Technical Service Bulletin: tsb100461

Eliminator Connection Plate Change

This Technical Service Bulletin informs the field of an Eliminator connection plate change for use on the QSK45/60 Series engines.

07601165

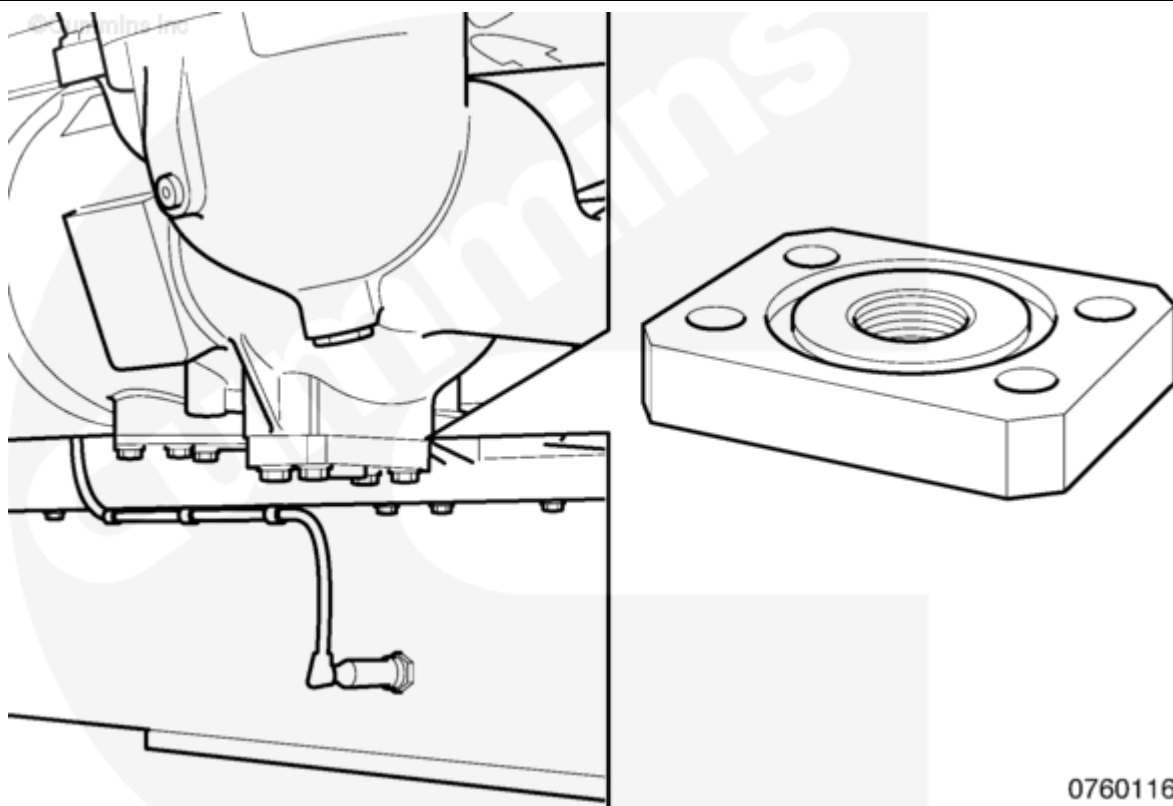
The Eliminator connection plate material has been changed from aluminum to steel. Both parts are interchangeable and are exactly the same, apart from material type. The current o-ring (Part Number 3393437) **must** still be used with this plate.

The graphic below shows the component as installed on the engine and as a separate component.

Old part number: 4100434

New Part Number: 3637968
